HISTORIC AND DESIGN REVIEW COMMISSION

HDRC CASE NO: 2021-026
COMMON NAME: Unaddressed lot to the immediate south of 334 Burleson, on N Mesquite
ADDRESS: 334 BURLESON ST
LEGAL DESCRIPTION: NCB 519 BLK 24 LOT E 42 FT OF N 134.09 FT OF 8
ZONING: IDZ-1, H
CITY COUNCIL DIST.: 2
DISTRICT: Dignowity Hill Historic District
APPLICANT: cesar sosa/5 ELEMENTS INTERNATIONAL LLC
OWNER: Ruben Lara/5 ELEMENTS INTERNATIONAL LLC
TYPE OF WORK: Construction of two, 2-story residential structures
APPLICATION RECEIVED: February 04, 2021
60-DAY REVIEW: Not applicable due to City Council Emergency Orders
CASE MANAGER: Edward Hall

Historic and Design Review Commission
Design Review Committee Report

PROJECT NO. S-363
CONSTRUCTION DOCUMENTS
10 SEPTEMBER 2020

1 NORTH ELEVATION
SCALE: 1/4" = 1'-0"

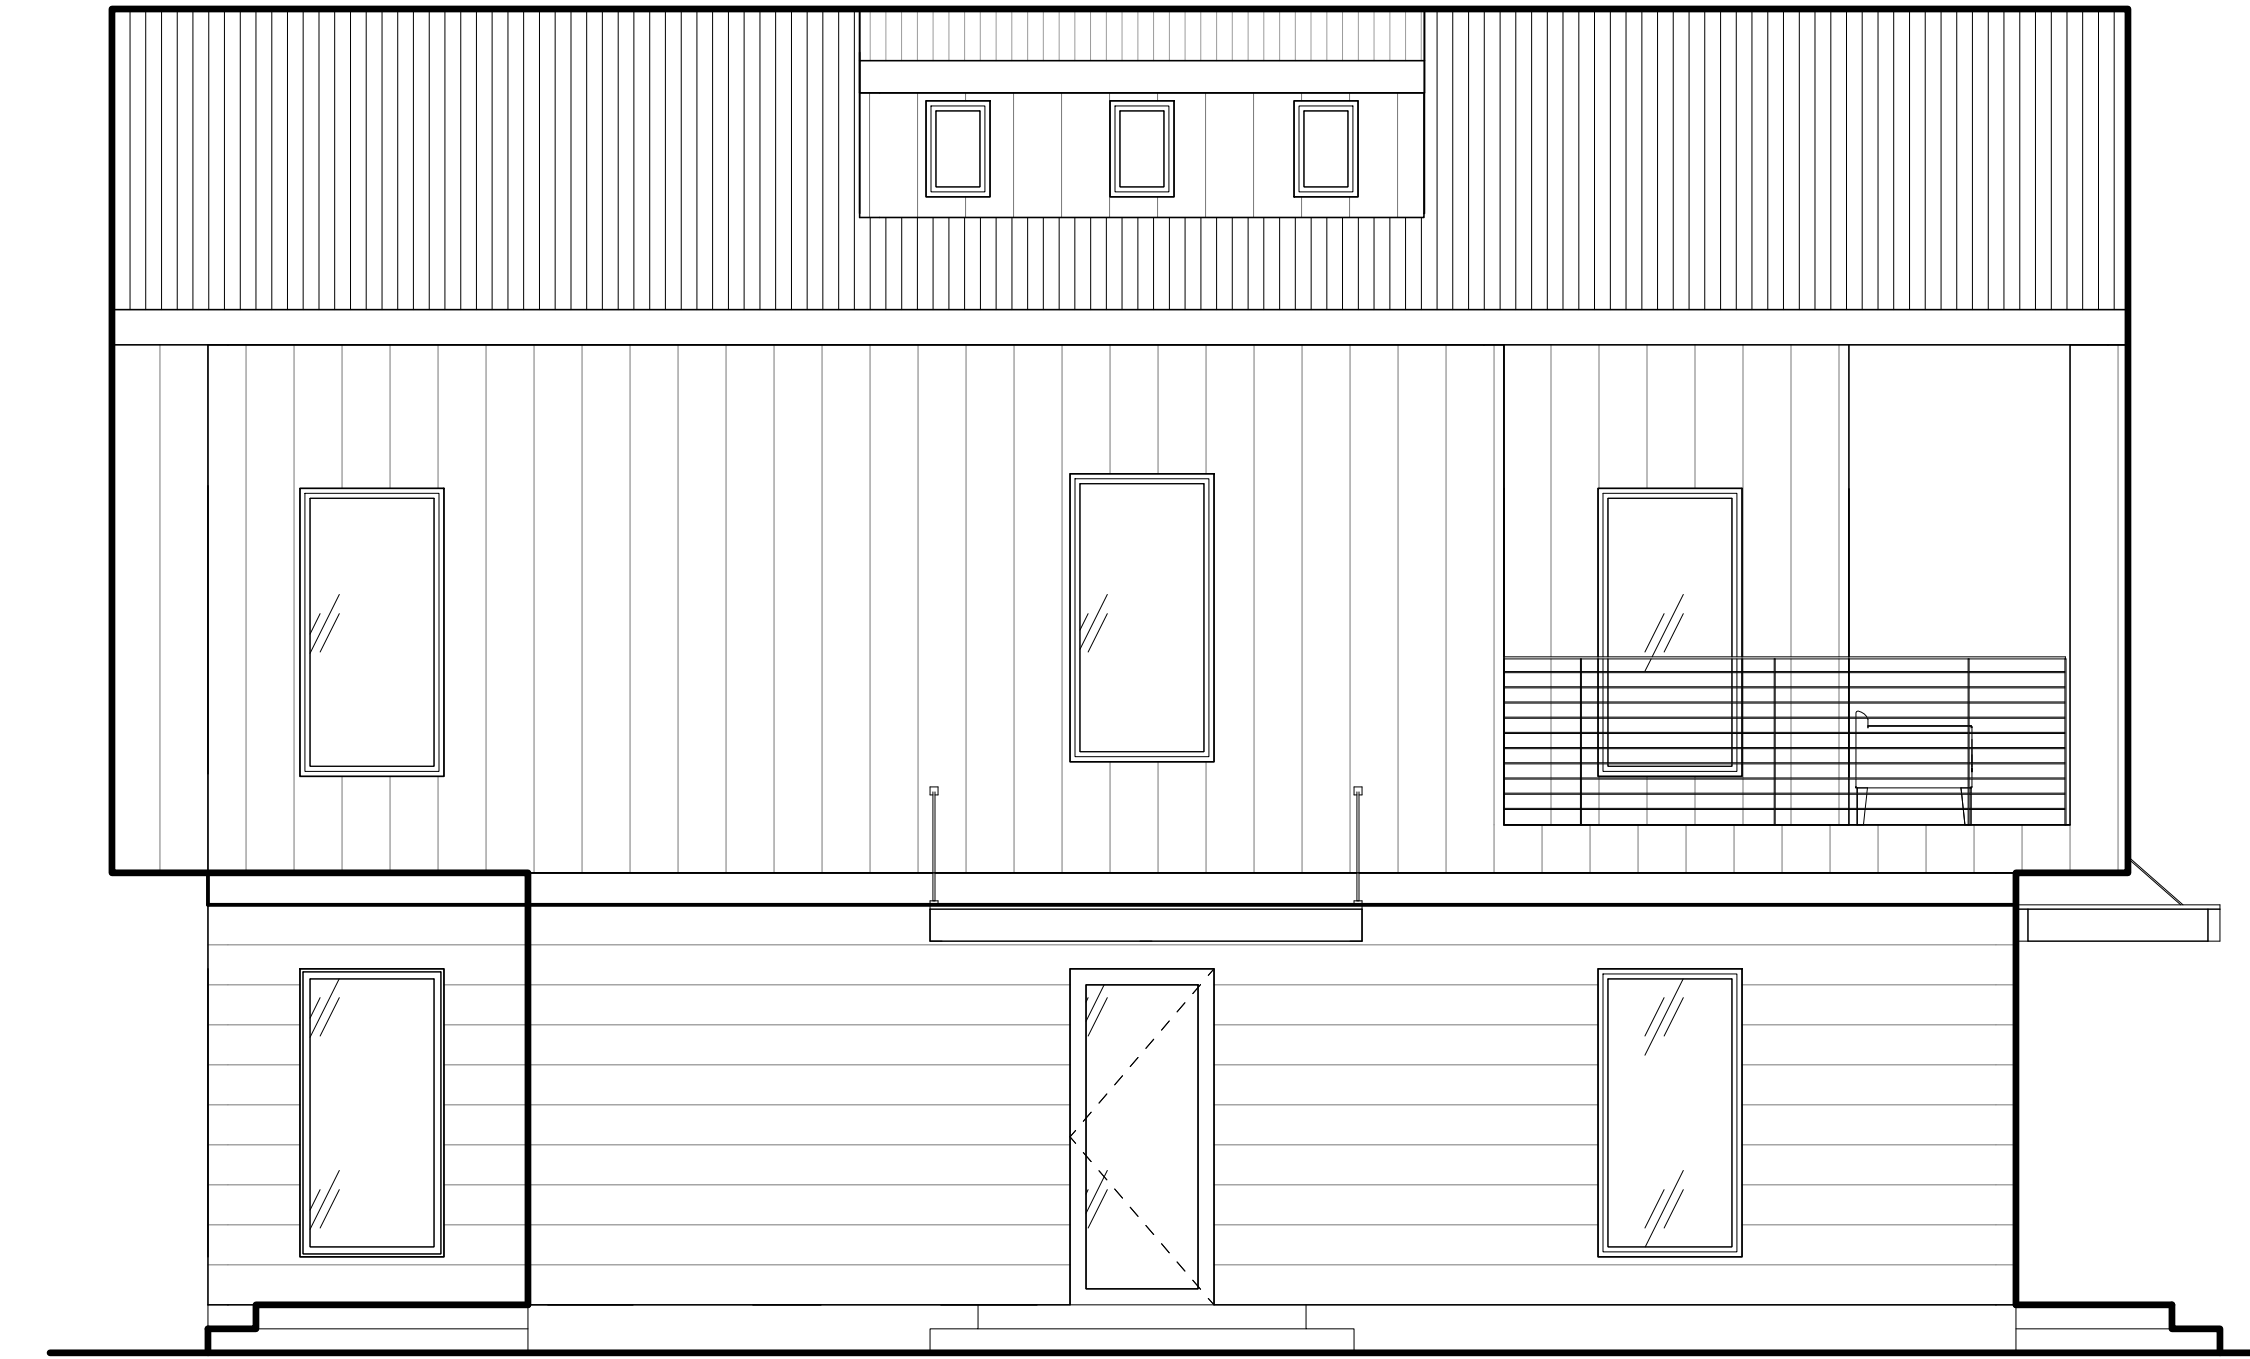
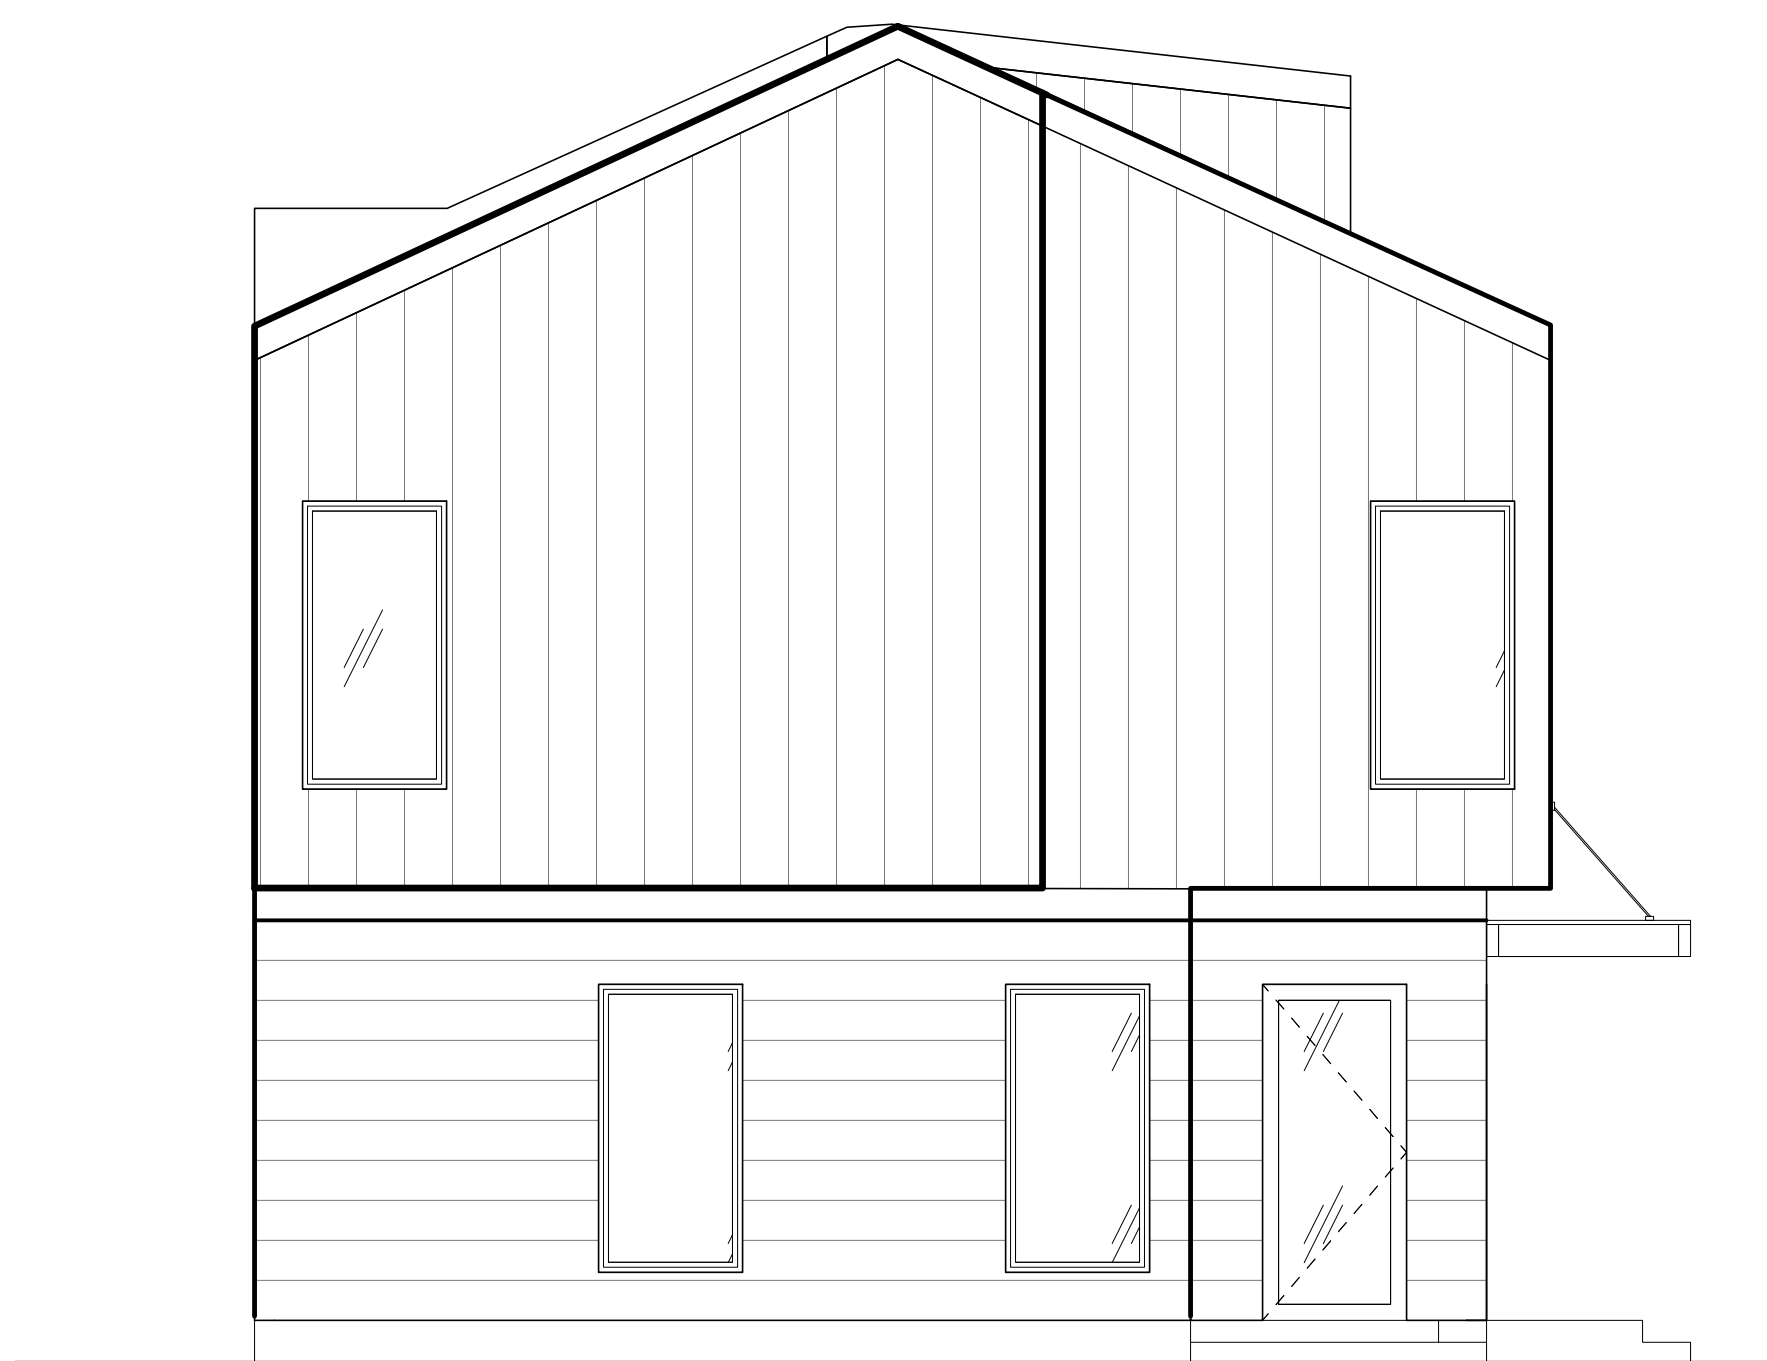
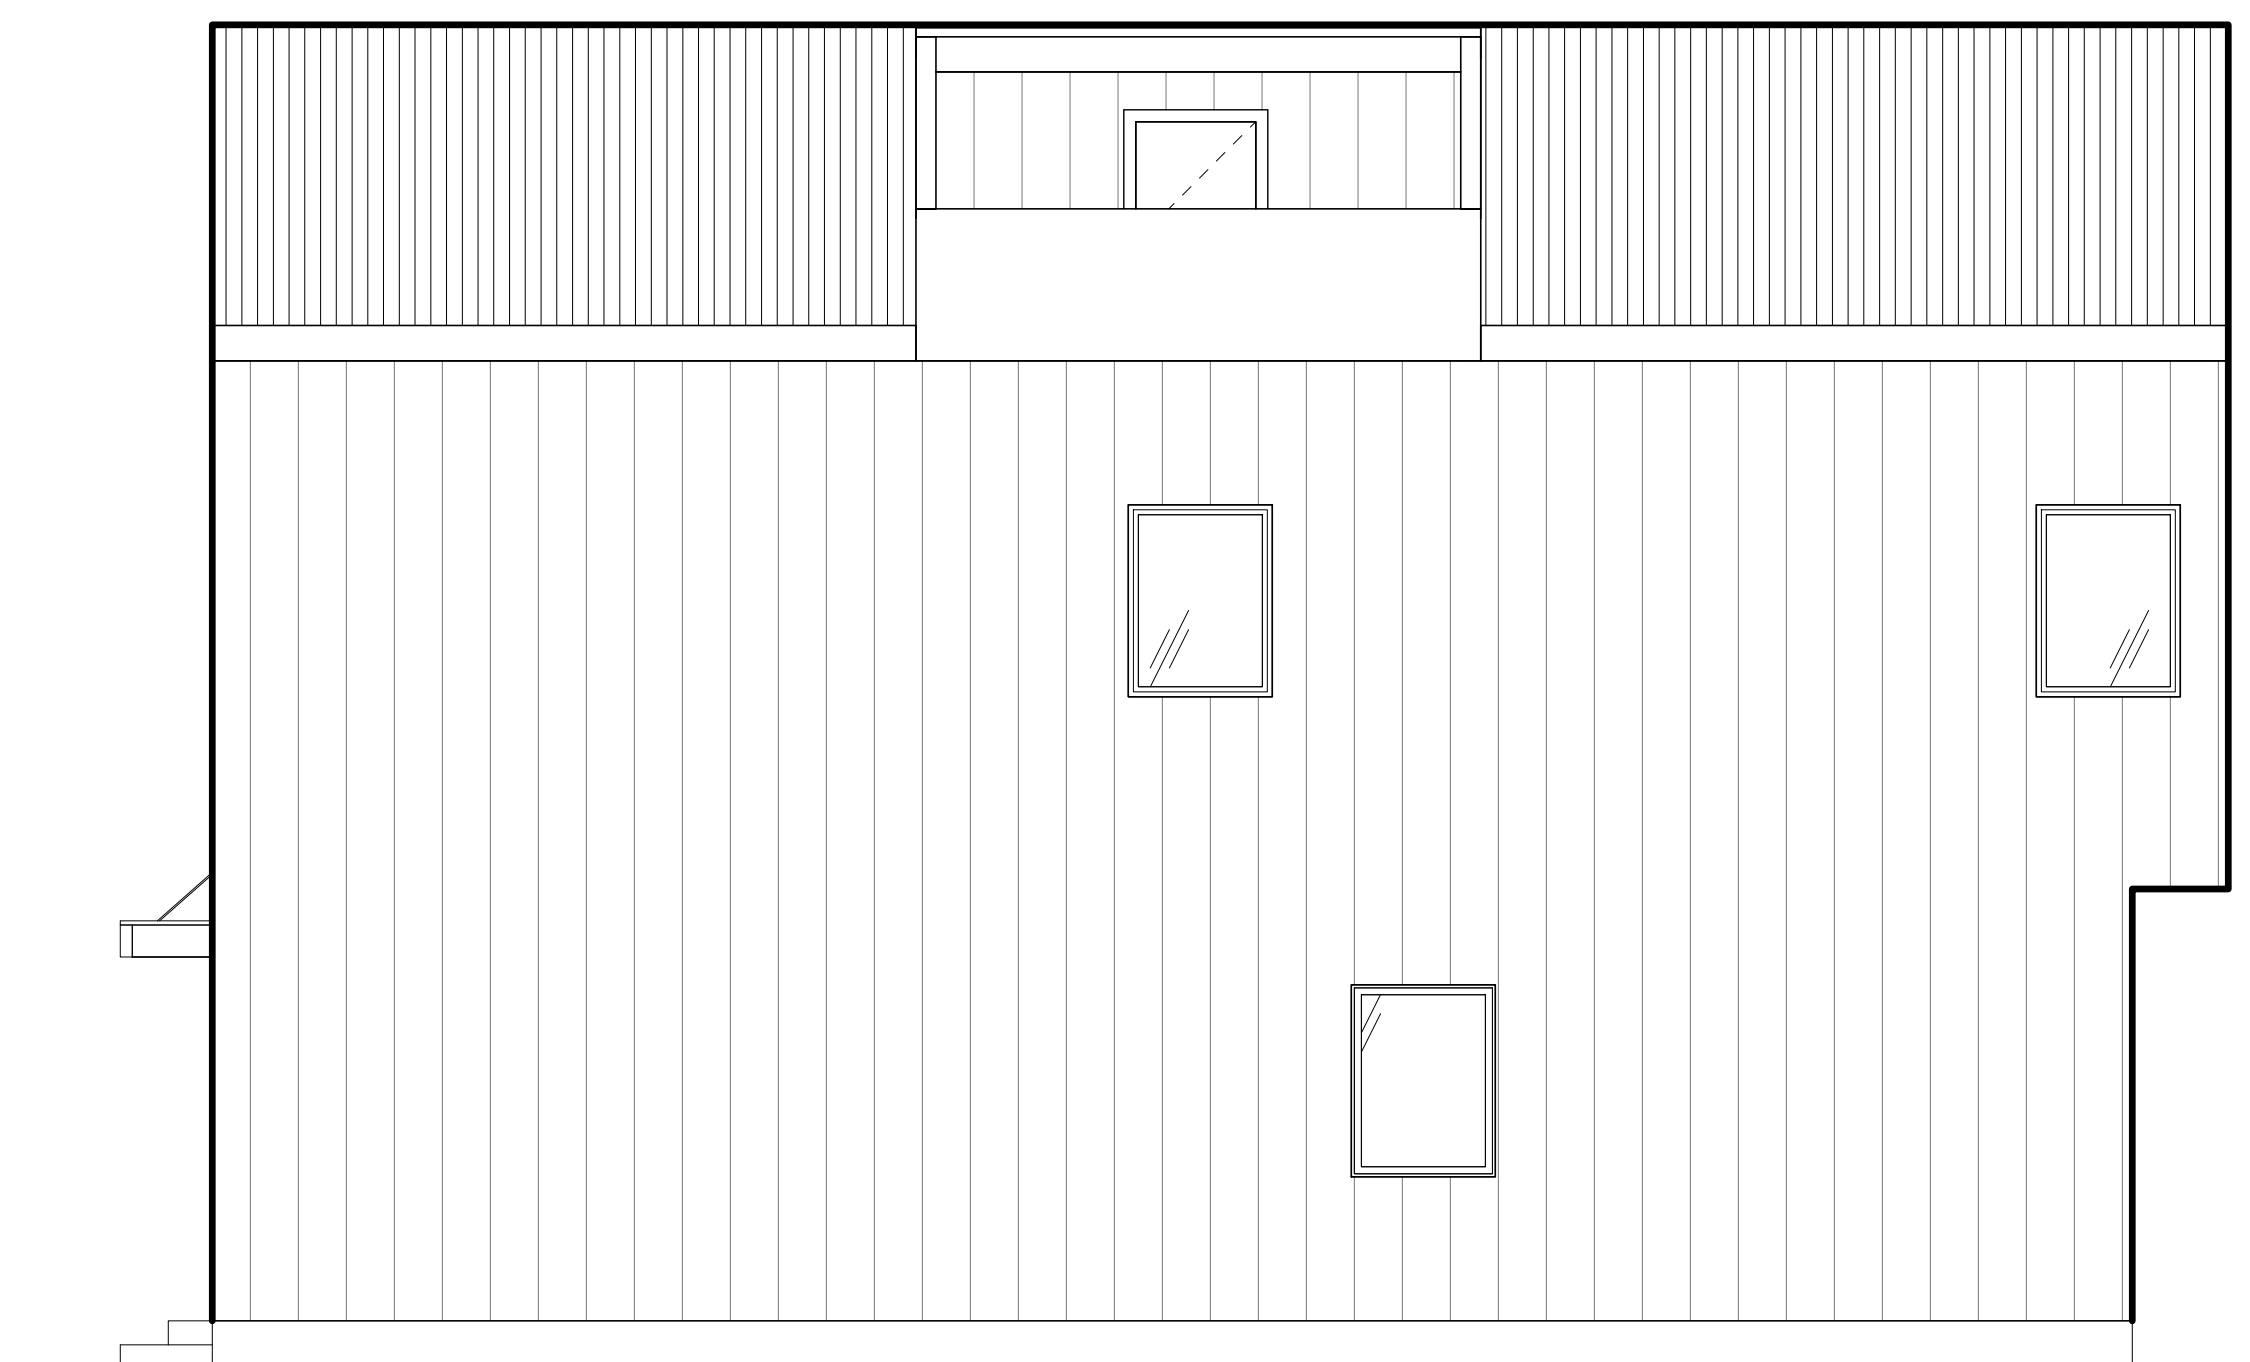
- 1b. **SCALE & MASS** – Per the Guidelines for New Construction 2.A.i., a height and massing similar to historic structures in the vicinity of the proposed new construction should be used. In residential districts, the height and scale of new construction should not exceed that of the majority of historic buildings by more than one-story. As noted in finding b, this block of Burleson features all one story structures. Staff does not find the proposed height to be consistent with the Guidelines.

- 1c. **ENTRANCES** – According to the Guidelines for New Construction 1.B.i., primary building entrances should be oriented towards the primary street. The applicant has not proposed design elements that present a primary building entrance. Staff finds that architectural elements that are found historically within the district that relate to building entrances should be incorporated into the design, such as porches and porch massing.

- 1d. **FOUNDATION & FLOOR HEIGHTS** – Per the Guidelines for New Construction 2.A.iii., applicants should align foundation and floor-to-floor heights within one foot of floor-to-floor heights on adjacent historic structures. The applicant has proposed to construct the structure on grade with no visible foundation height. This is not consistent with the Guidelines.

- 1e. **ROOF FORMS** – The applicant has proposed a primary roof form to feature a front facing gabled roof. The proposed roof features two dormer elements, one of which features a void that allows for a rooftop seating element. Generally, staff finds the proposed roof forms to be atypical of those found historically within the district and inconsistent with the Guidelines.

- 1f. **WINDOW & DOOR OPENINGS** – Per the Guidelines for New Construction 2.C.i., window and door openings with similar proportions of wall to window space as typical with nearby historic facades should be incorporated into new construction. The applicant has proposed window and door openings that are contemporary in profile and size. Staff finds that the proposed window and door openings are not consistent with the Guidelines and should be modified.

- 1j. **ARCHITECTURAL DETAILS** – The applicant has proposed new construction that features contemporary forms. Generally, the proposed massing, lack of porch massing, window and door openings, materials and façade detailing are not consistent with the Guidelines.

- ii. That the applicant reduce the proposed massing to be consistent with the Guidelines, as noted in finding 1b.
 - iii. That the applicant incorporate both entrance massing and architectural entrance elements as noted in finding 1c.

- iv. That the applicant incorporate foundation and floor heights that are consistent with the Guidelines, as noted in finding 1d.
 - v. That the applicant incorporate roof forms that are consistent with the Guidelines as noted in finding 1e.

- vi. That the applicant incorporate window and door openings that are consistent with the Guidelines as noted in finding 1f.
 - vii. That the applicant incorporate materials and windows materials that are consistent with the Guidelines as noted in findings 1h and 1i. Wood or aluminum clad wood windows should be installed as noted in finding 1i and in the applicable citations.
